SERVICE BULLETIN 62

SUBJECT: POSSIBLE WING LEADING EDGE INTERFERENCE WITH THE NOSE GEAR BOX AND THE FUSELAGE REINFORCEMENT RIB

APPLICATION: GLASAIR III KITS THROUGH SERIAL NUMBER 3128.

FIGURE (1)

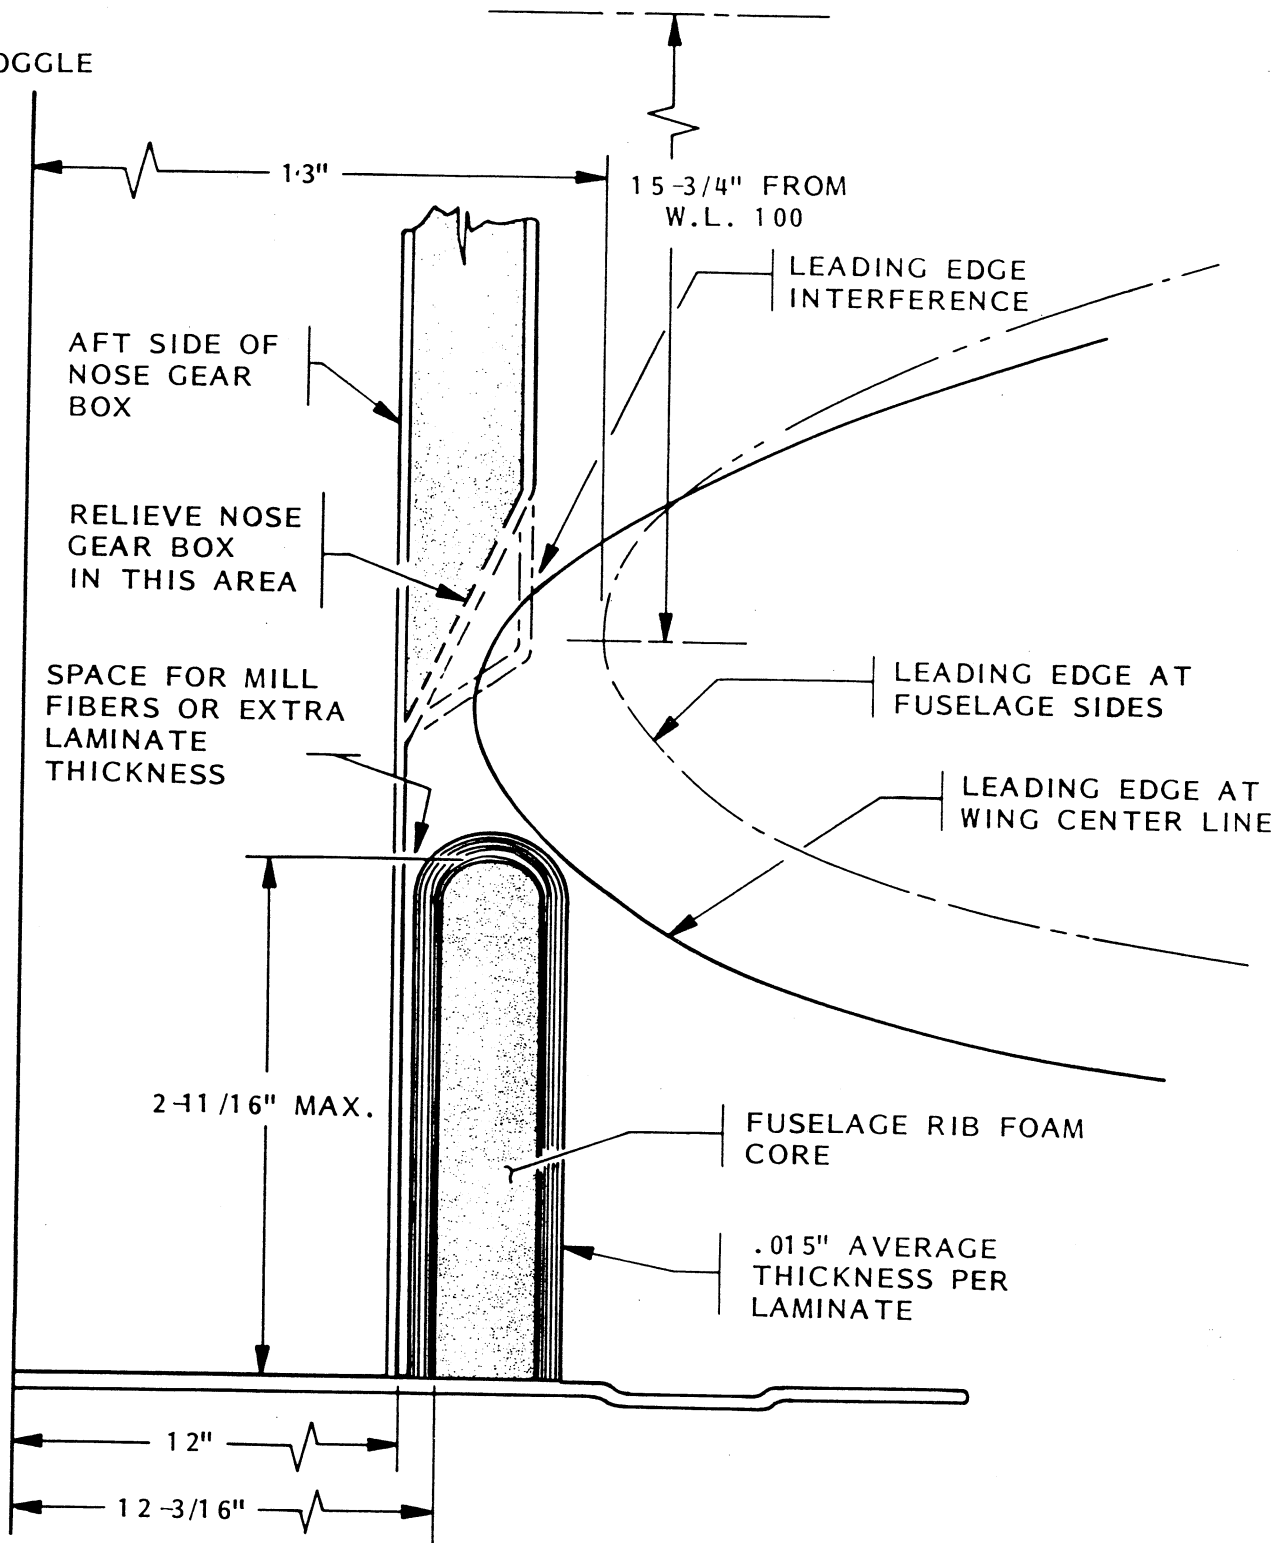
DESCRIPTION: The clearances between the wing leading edge and both the nose gear wheelwell box and the fuselage reinforcement rib are very tight. If the laminates on the fuselage rib or nose gear box are slightly too thick, or if the wing is mispositioned relative to the fuselage by as little as 1/16", the wing leading edge can contact part of the fuselage structure. FIGURE (1) shows the wing leading edge position relative to the fuselage reinforcement rib and the nose gear box if installed exactly according to the Instruction Manuals. Because we have had several reports of fuselage rib to wing interference from builders in the field, we recommend performing Step 2 (described below) to provide ample clearance.

Before installing the nose gear wheelwell box, bevel the outside laminates and foam core at the top of the cutout on the aft side, as shown in FIGURE (1). Then apply a two-layer laminate over the relieved area to replace the laminates that were removed. Install the wheelwell box as described in the Fuselage Assembly section of the Instruction Manuals.

FIGURE (2)

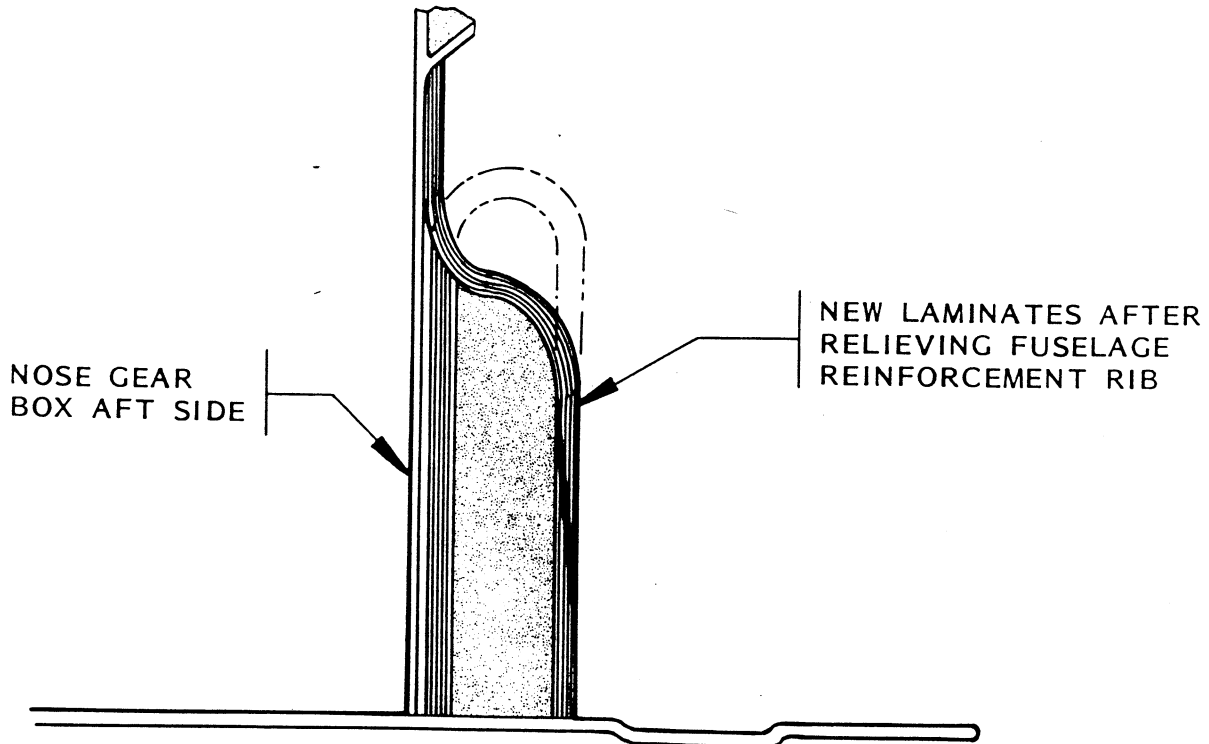
If you encounter interference problems when fitting the wing to the fuselage, the nose gear wheelwell box and/or the fuselage reinforcement rib may be relieved to provide clearance for the wing leading edge, as shown in FIGURES (1) and (2).

The important consideration, if modification is necessary, is to replace all the laminates that are removed. For example, the laminates at the center of the fuselage reinforcement rib are 10 layers thick. The area must be relieved sufficiently to provide clearance when the 10 layer laminate thickness is re-applied. When relieving the existing laminates, bevel them to a shallow angle (10 to 1), and then, when reapplying the laminates, cut each layer slightly larger than the last to avoid abrupt changes in thickness in the finished laminate, as shown in FIGURE (2).
